From: Medak, Christine <christine_medak@fws.gov>
Sent: Wednesday, September 14, 2016 1:17 PM
To: GYU@dpw.lacounty.gov
Cc: Rogers, Bonnie L SPL; Mari (Schroeder) Quillman; Vargas, Jessica M SPL; Chirdon, Matthew@Wildlife; Jonathan Snyder
Subject: Review of On-Site Mitigation Hydrology Justification
Attachments: Appendix_D_hydrology-report_small.pdf

Devil's Gate Sediment Removal and Management Plan
On-Site Mitigation Hydrology Justification

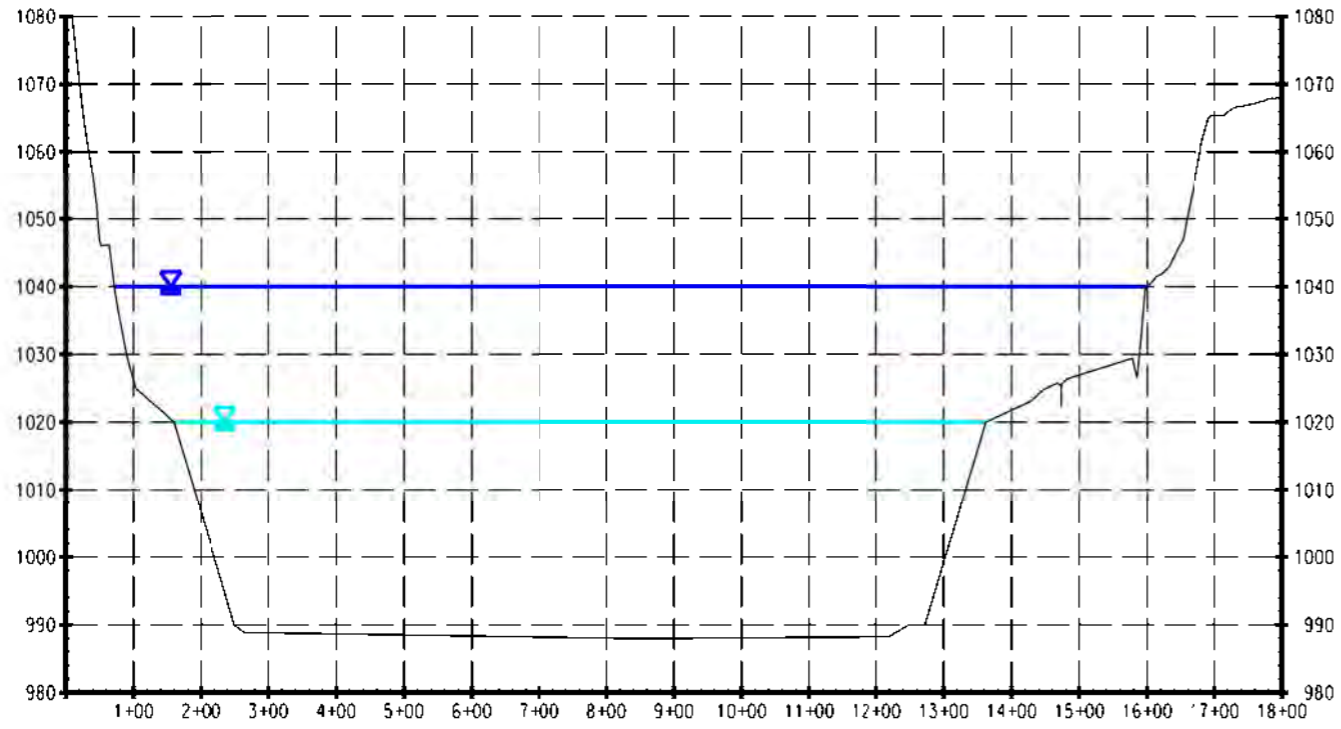
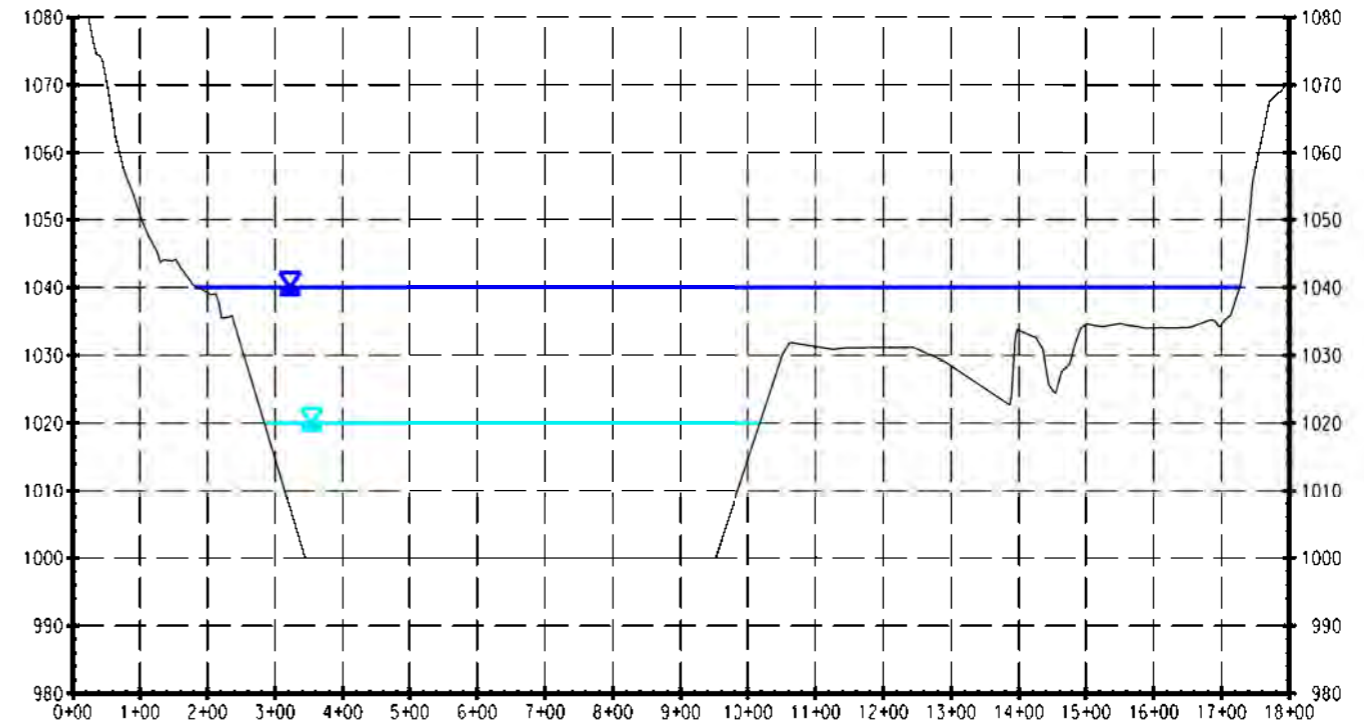
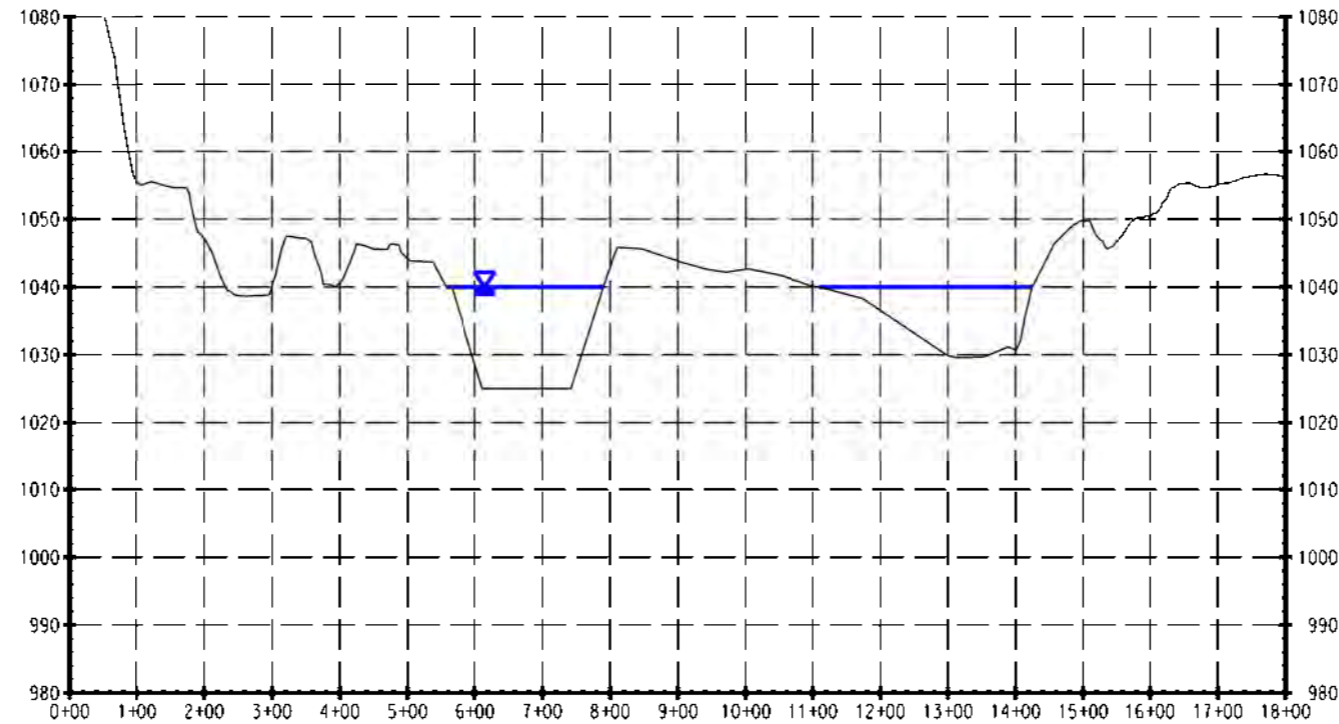
11) Attachments 15 and 17 compare cross sectional profiles in 2009 and with the proposed project. While the 1040' elevation contours appear similar, there is substantially more capacity below 1020' elevation with the proposed project. We are concerned the increase in capacity and confinement of flows within the permanent impact footprint will decrease the frequency of surface flows reaching remaining habitat. Riparian vegetation suitable for vireo breeding, feeding and sheltering consists of a complex structure of understory, midstory and canopy vegetation that is maintained by natural processes. Restoration conducted in areas that will be isolated from natural processes will need to be managed in a way that not only provides adequate soil moisture but also maintains the structural diversity necessary to support the species. The management actions necessary to maintain habitat for the vireo over the long term should be included as part of the proposed habitat restoration and management plan.
